PLANNING COMMITTEE – 6 AUGUST 2019

Application No: 19/00192/RMA

Proposal: Application for variation of condition 01 to be varied to include for

Location: Land Off Hutchinson Road, Newark On Trent

1/31/2017 with approved 'red line boundary' shown in blue.

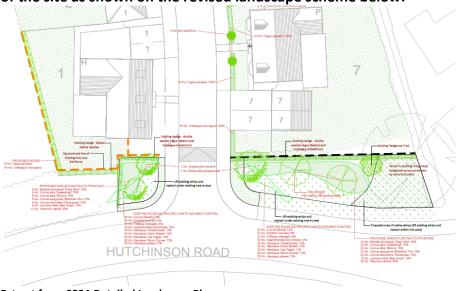
6. The Proposed Site Plan (1/31/2017) approved by 17/01573/RMA below shows that the original hedgerow along the west boundary of the site was not located along the red line boundary of the site.

- 7. Therein lies an issue with the full enforceability of a breach of condition in relation to compliance with Condition 3 of 17/01573/RMA in respect of all boundaries as this condition requires 'precise details of all the existing and proposed boundary treatments along the red line boundary of the site' and this hedgerow was not located along the red line boundary. Nevertheless, had Officers been aware that the true red line boundary of the application site was not located along the west boundary of the site as shown on the plans submitted at the time, it is highly likely that a replacement hedgerow would have been recommended along this boundary in any event.
